Recall Campaign Bulletin

Campaign No. 2025010005, January 2025

SUBJECT: **Model EQS (296 platform)**
Model Year 2023

Replace Mounting Brackets in Roof

Figure 1

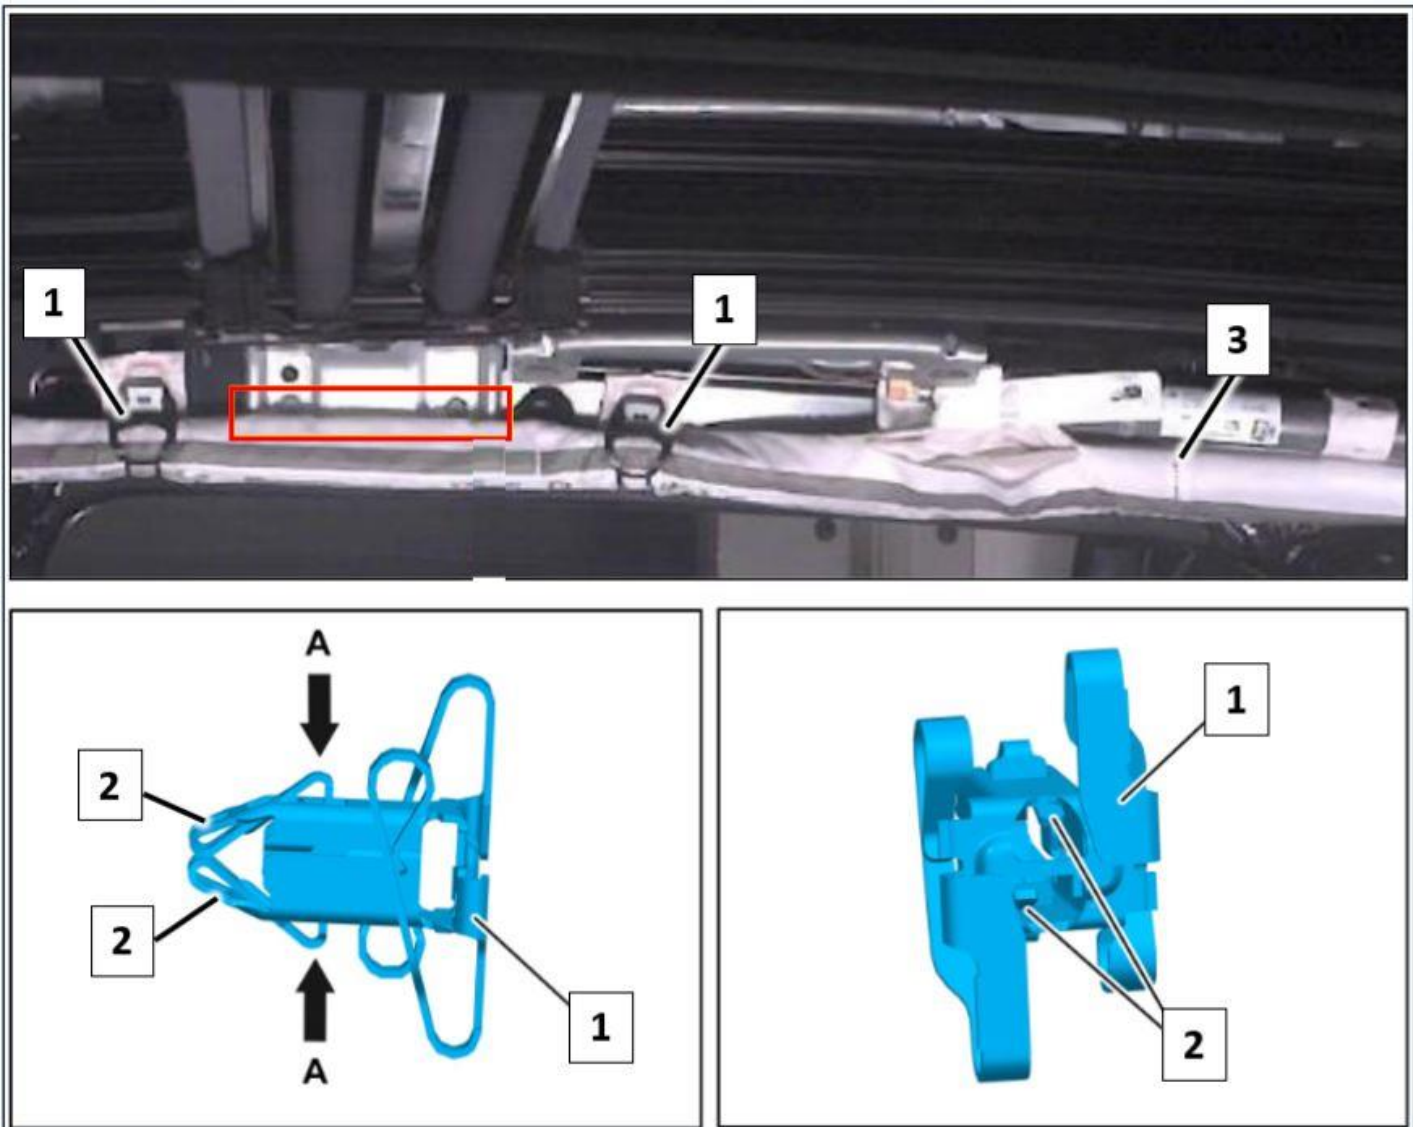
1. Adjust driver and front passenger seat to fully reclined position.
2. Remove headliner and place on the seat backrests.
i For basic information, see AR68.30-P-4300EQS.
3. Loosen the clips (**Figure 1, 1**) on the left and right window airbag (**Figure 1, 3**).
i To do so, press together tabs (**Figure 1, 2 & A**) using suitable needle nose pliers, and remove clips (**Figure 1, 1**).
NOTE: A relatively large amount of force will be required to remove the clips (**Figure 1, 1**).

Figure 2

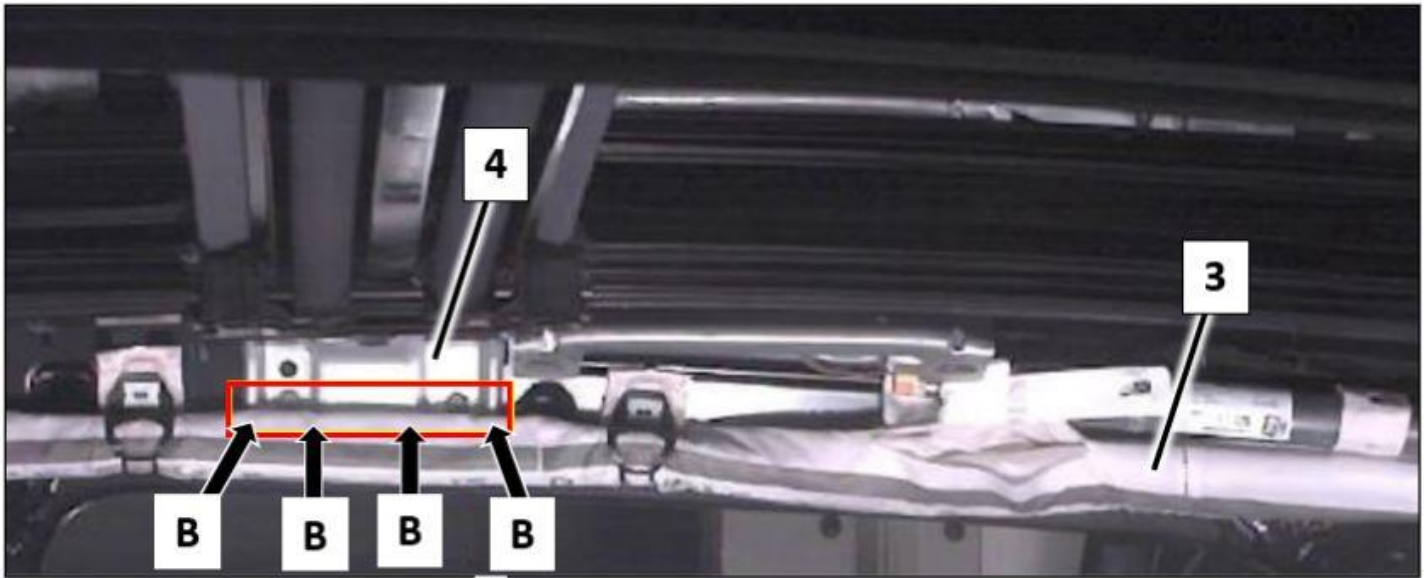
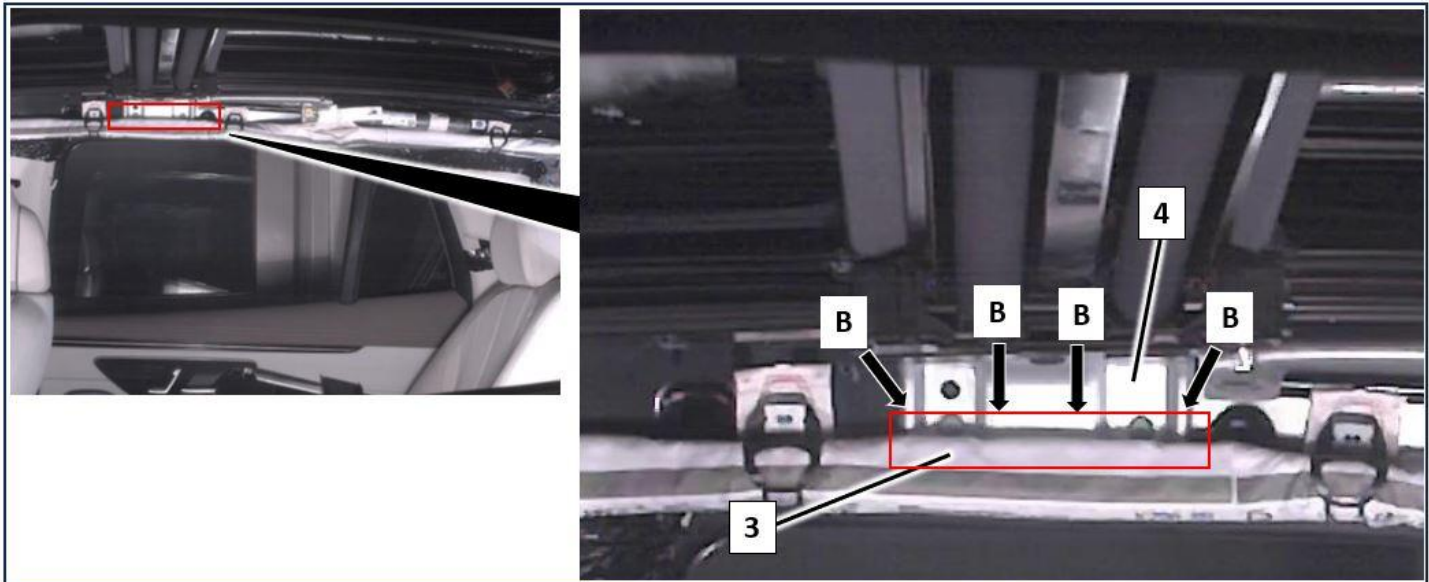
4. Check contact surface of the window airbag sleeve on the left and right window airbags (**Figure 2, 3**) for damage.
i Check lower area of mounting bracket edge (**Figure 2 and 3, B**) for damage.

- a. If window airbag sleeve (**Figure 2 and 3, 3**) is **not damaged**, only perform **Work Procedure A**.
- b. If window airbag sleeve (**Figure 2 and 3, 3**) is **damaged**, perform **Work Procedure A and B**.

Figure 4

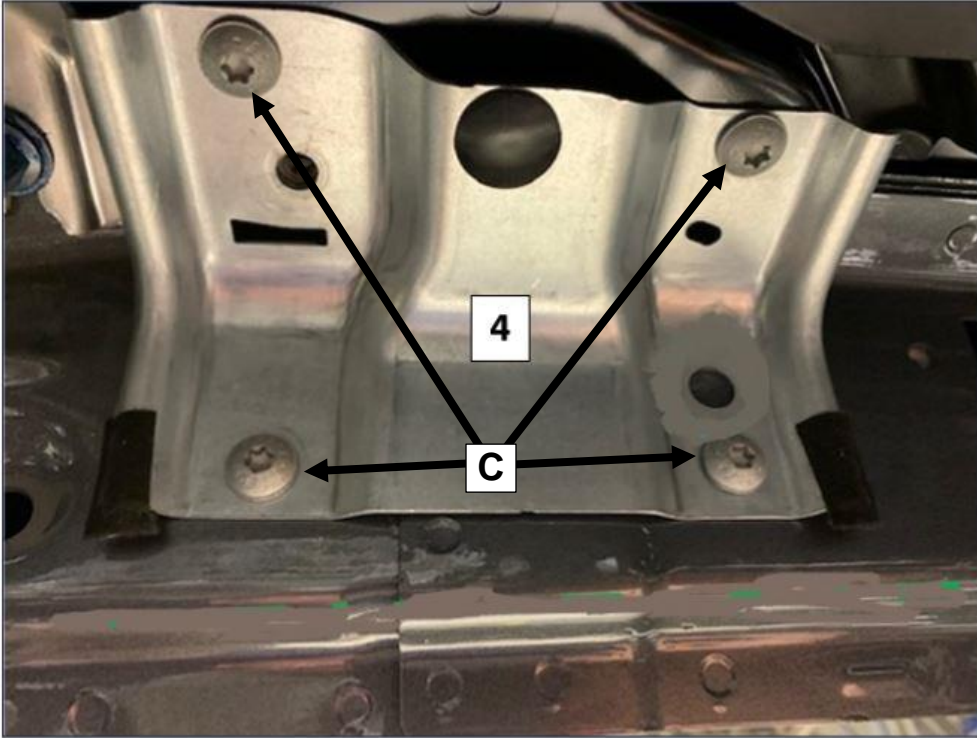
5. Replace mounting bracket (**Figure 4, 4**) on left and right B-pillar.

i To do so, unscrew mounting bracket screws (**Figure 4, C**) on left and right B-pillar (**Figure 4, 4**).

Nm Observe tightening torque of screws: **8 Nm**.
